GULF STATES UTILITIES COMPANY

River Bend Station-Unit 1
Docket No. 50-458

Enclosed is the Gulf States Utilities Company (GSU) response to Safety Evaluation Report (SER) Confirmatory Item #19 - Hydrogen Control (SER Section 6.2.5, Page 6-32/33.) Attachment 1 contains the GSU endorsements for various Hydrogen Control Owners Group (HCOG) submittals. These letters should be utilized to provide background and reference material for SER Confirmatory Item #19. Attachment 2 contains a revision to the Request for Additional Information (RAI) on the Hydrogen Ignition System (HIS) transmitted to W. J. Cahill (GSU) by A. Schwencer (Nuclear Regulatory Commission - NRC) on December 2, 1983 and supercedes the original GSU response from J. E. Booker (GSU) to H. R. Denton (NRC) dated December 30, 1983 (GSU Letter No. RBG-16679).

REQUEST FOR ADDITIONAL INFORMATION FOR USE IN THE EVALUATION OF
THE HYDROGEN IGNITION SYSTEM FOR THE RIVER BEND STATION, UNIT 1
MARK III CONTAINMENT

E&DCR C-14,170
PAGE 4 OF 11

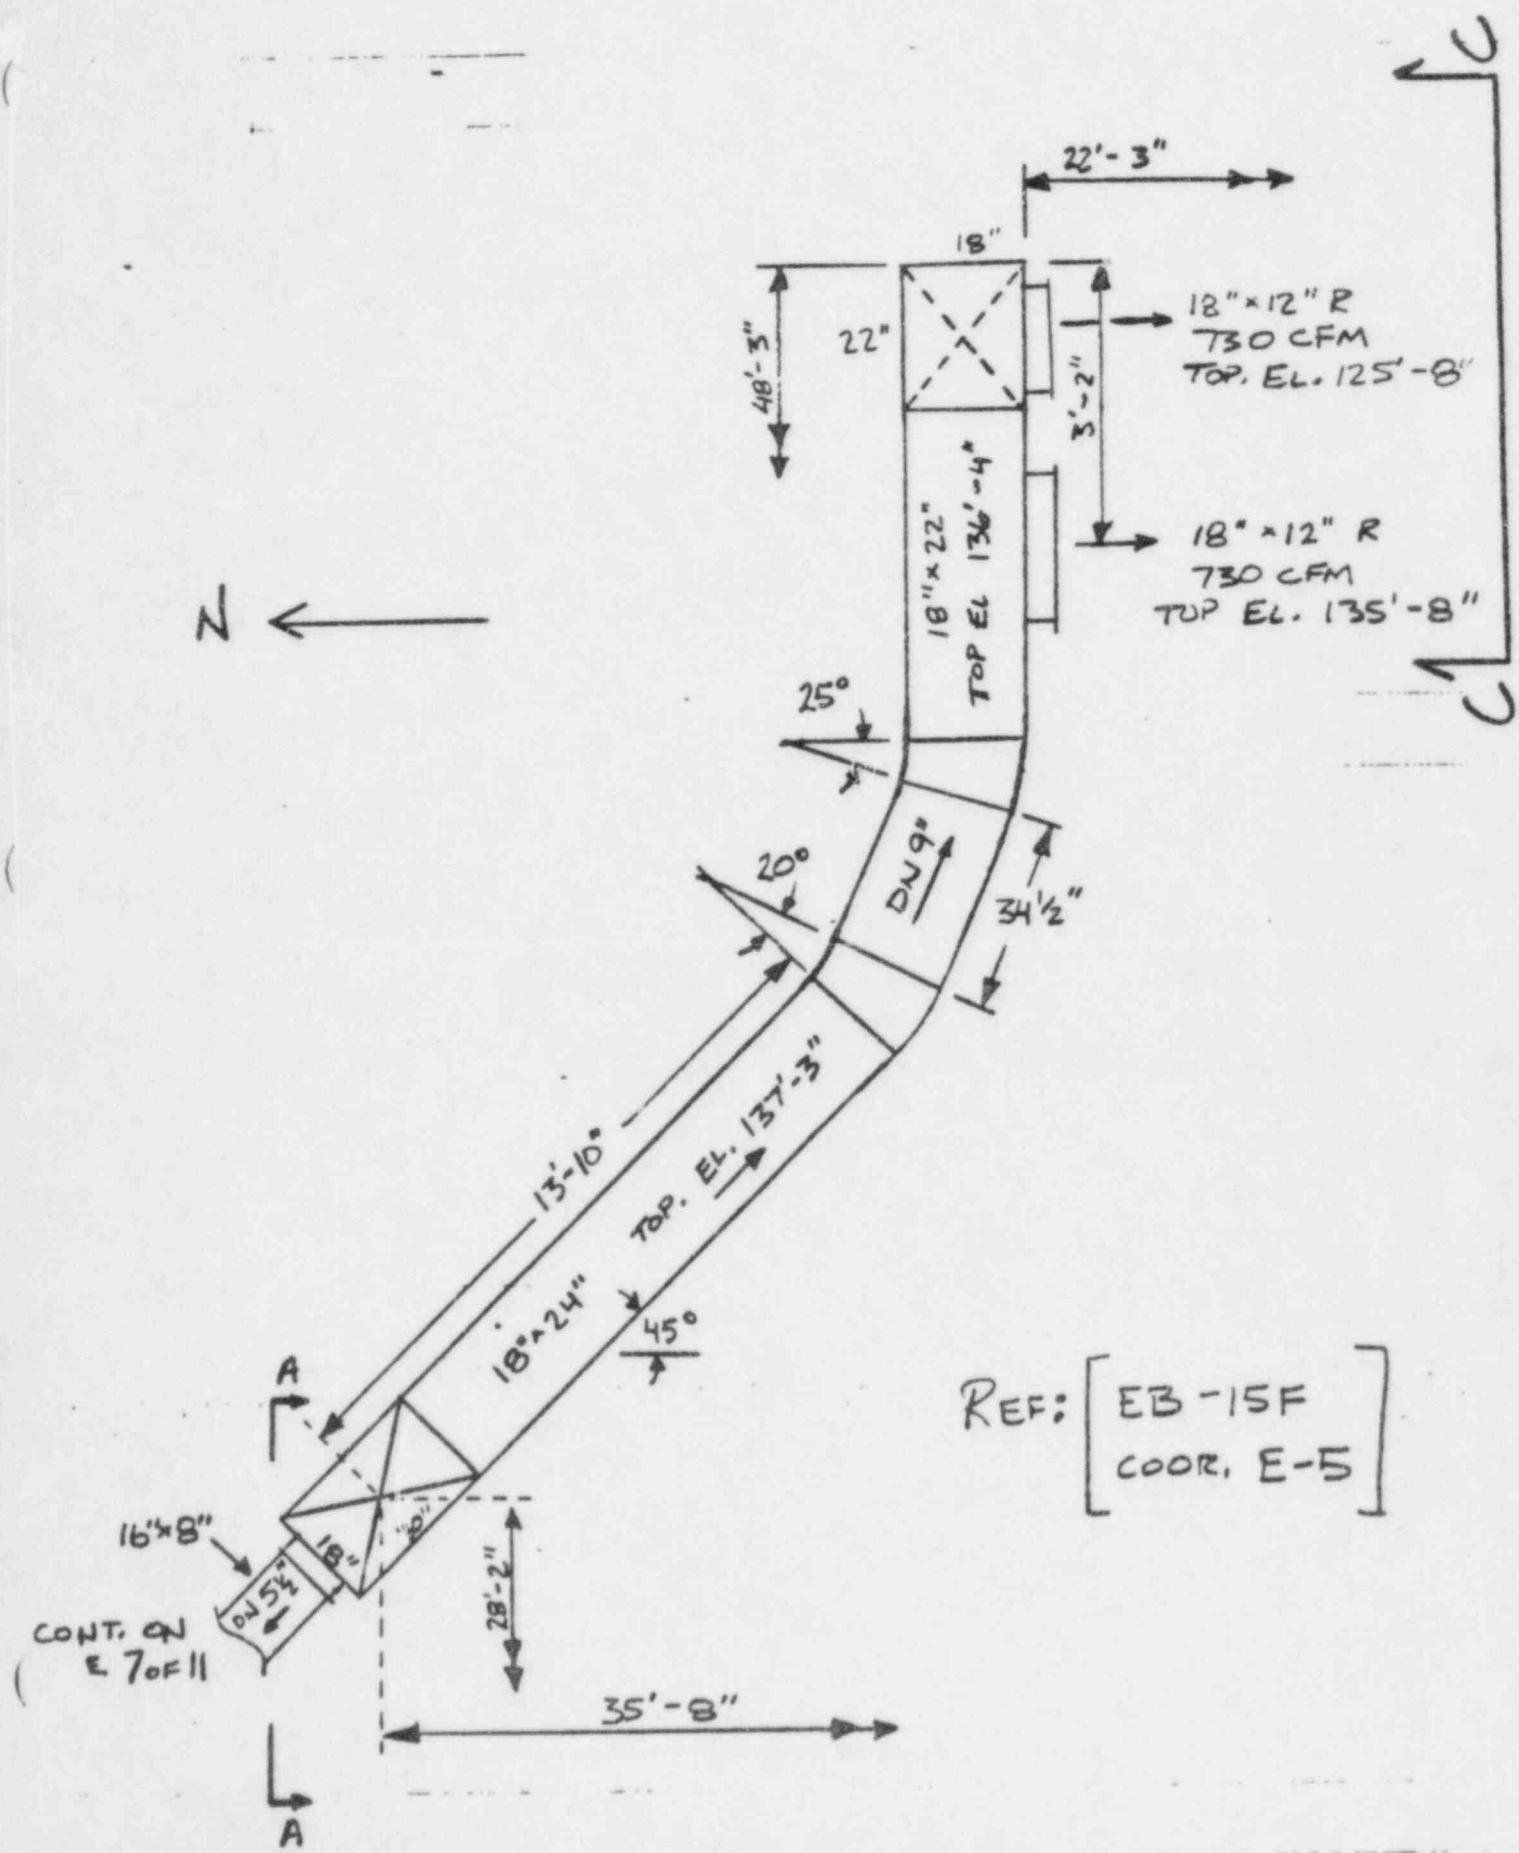
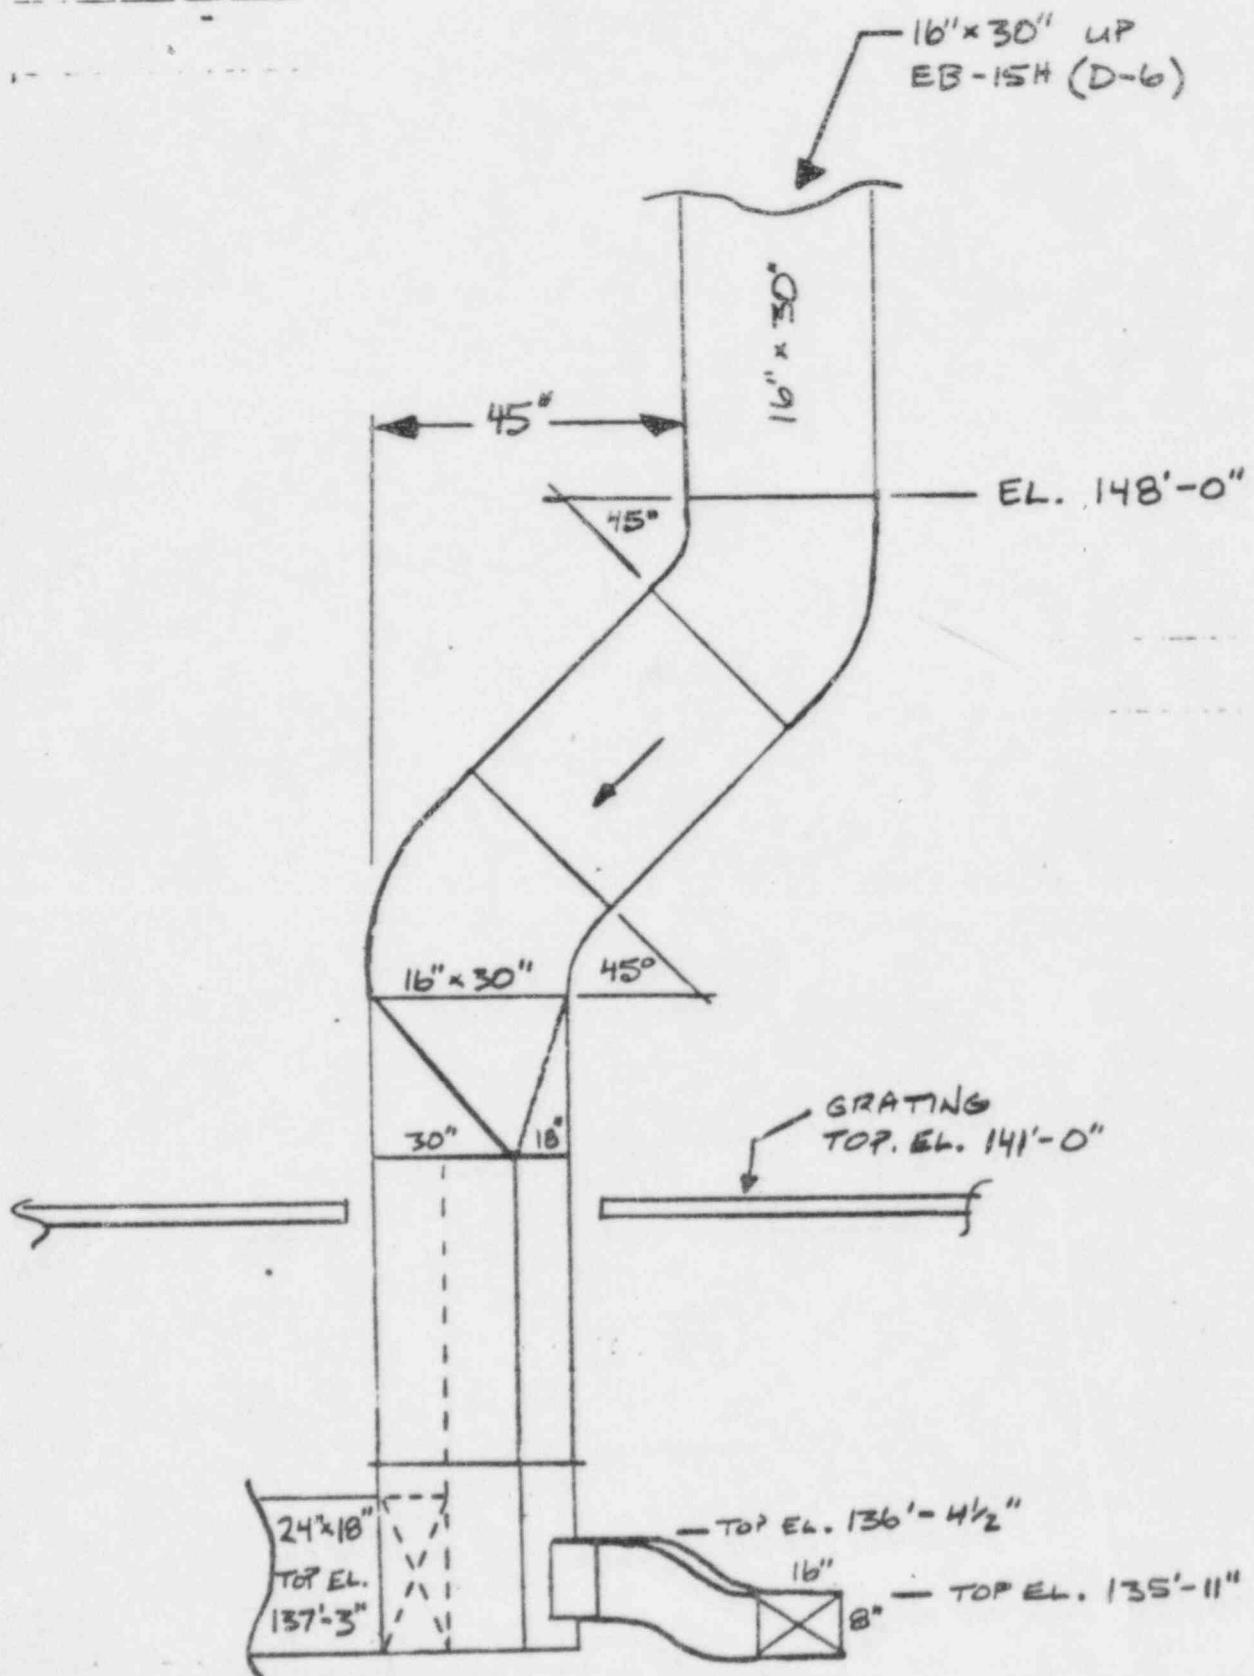
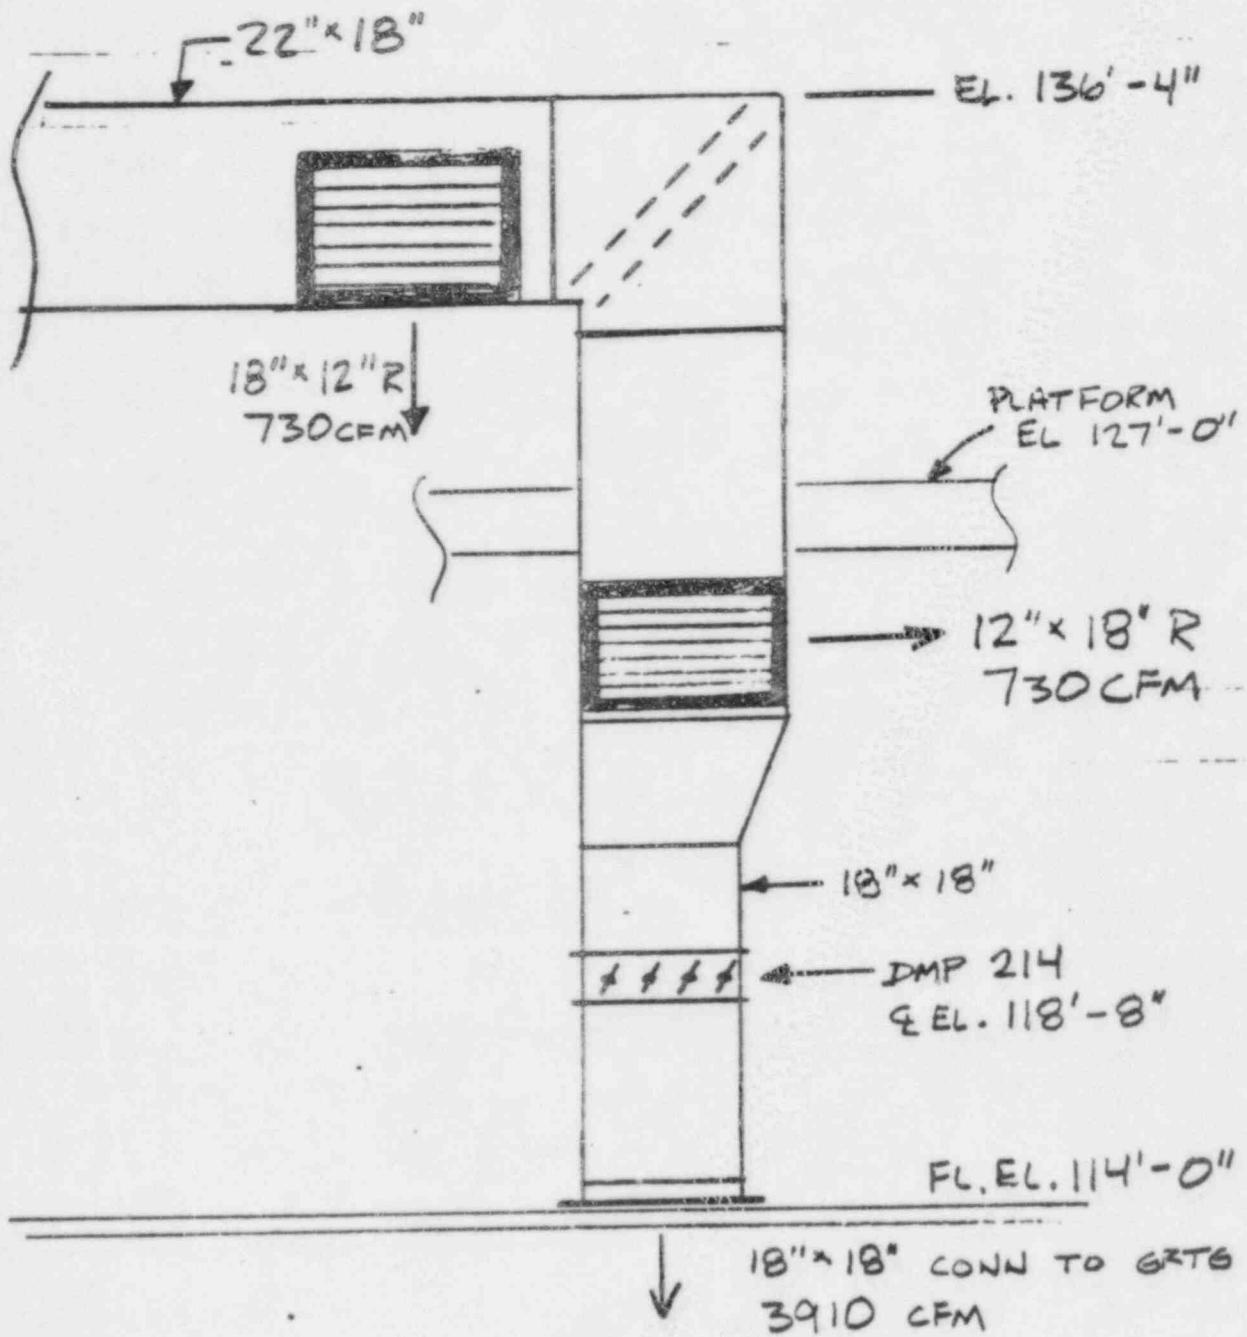
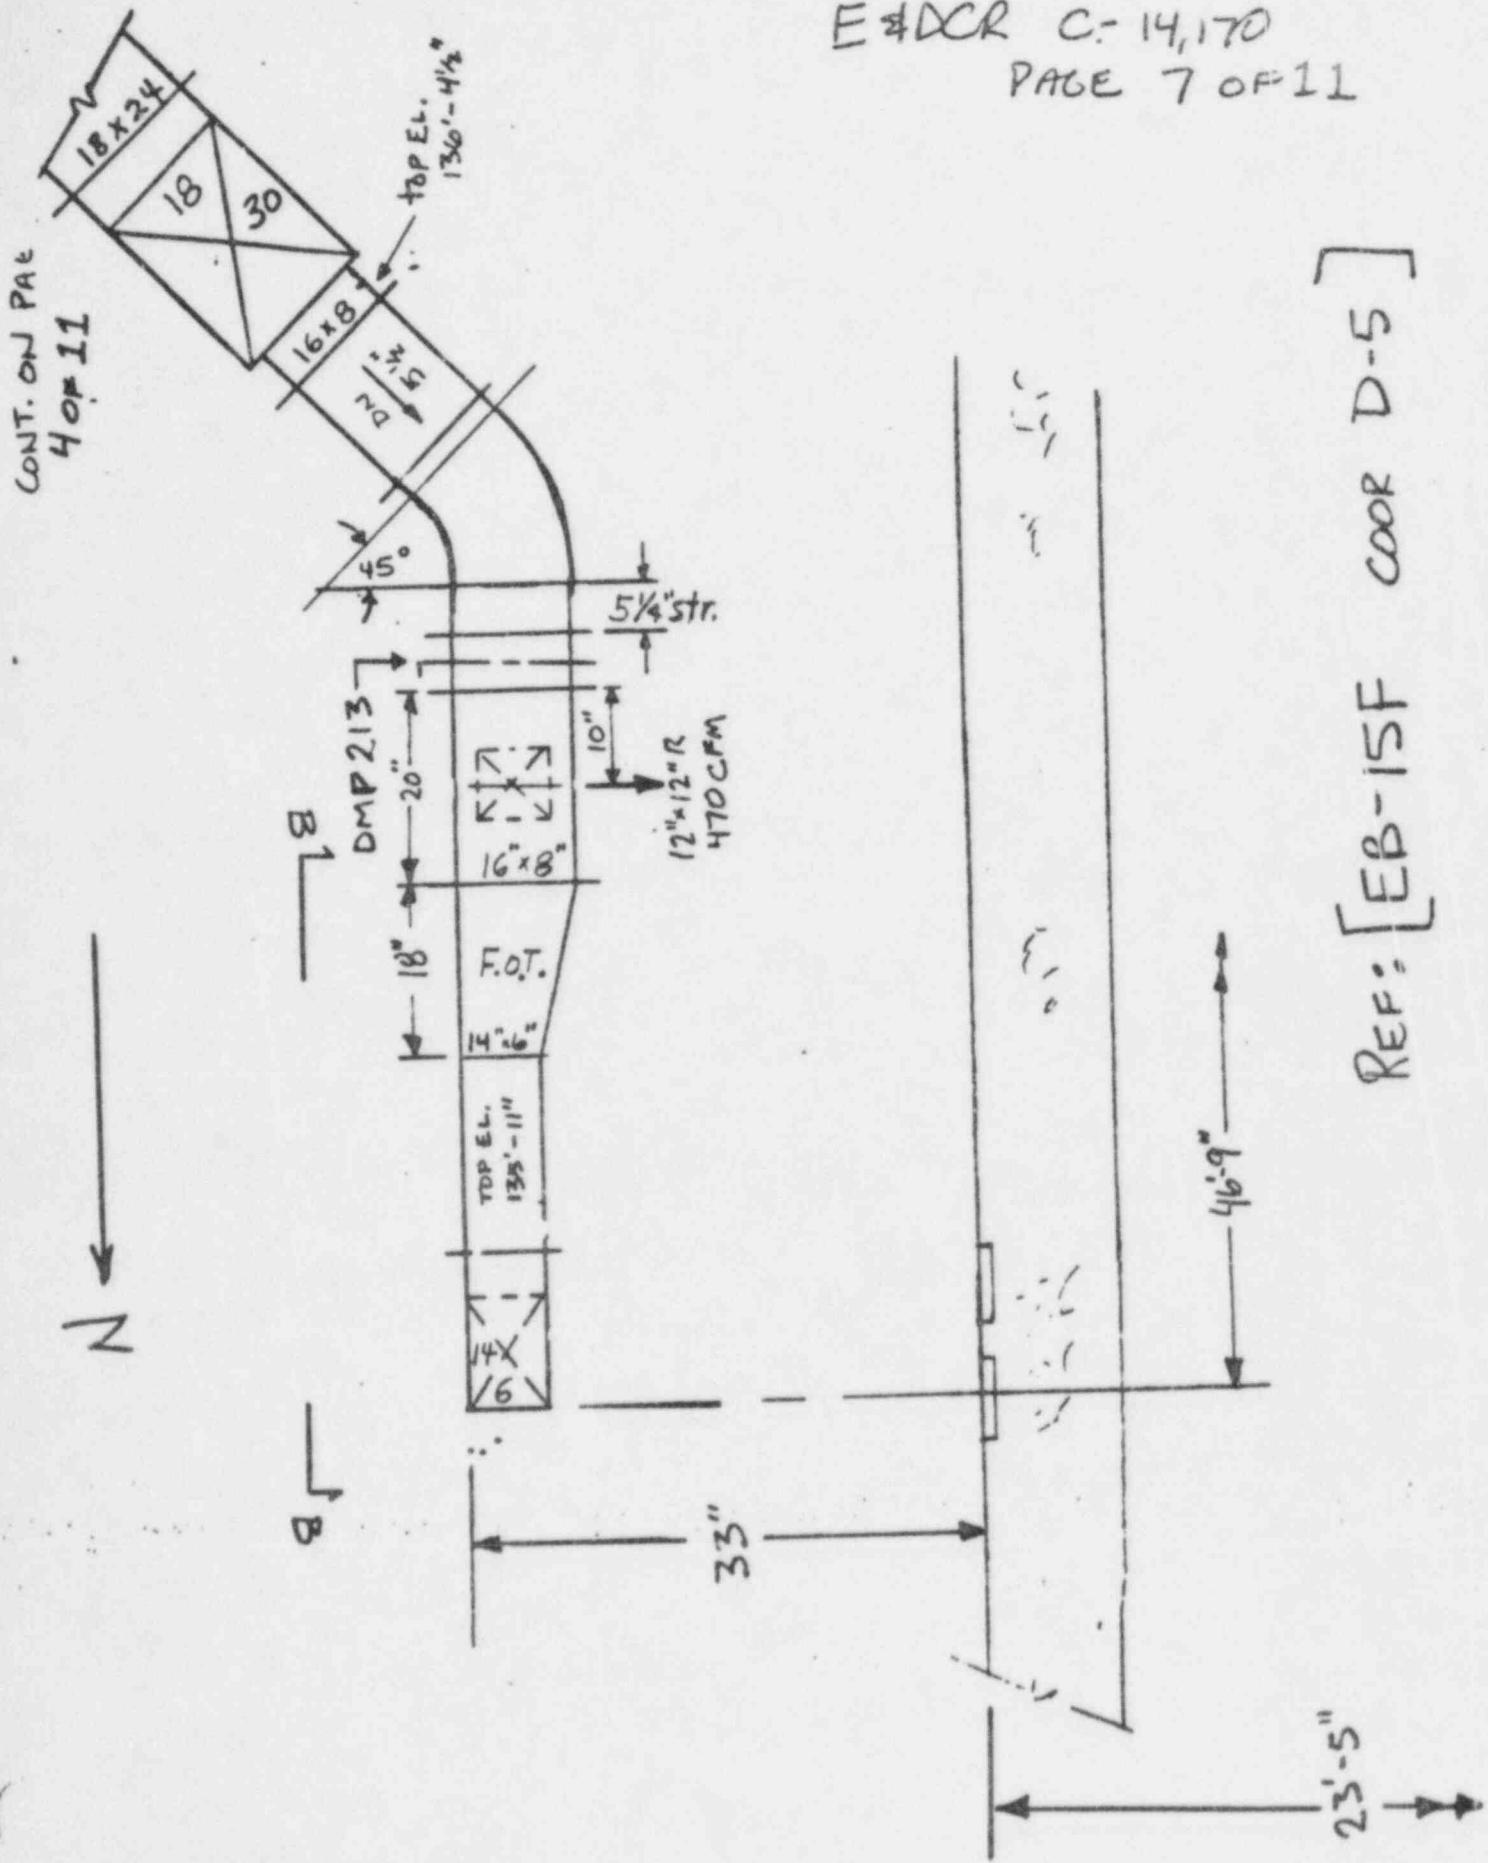
SEE SKETCH ON PAGE TWO FOR TENTATIVE DUCTWORK RELOCATIONS.
 DESIGN DWGS. EB-15F AND EB-15R WILL BE REVISED DEPICTING THE AS-BUILT CONFIGURATION.

EB-15F AND 15R SHALL BE REVISED INCORPORATING THE INFORMATION CONTAINED ON PAGES 4 THRU 8 OF THIS E&DCR.

THIS DUCT SYSTEM SHALL BE CHANGED
AS SHOWN ON PAGES 4 THRU 8
OF THIS E&DCR
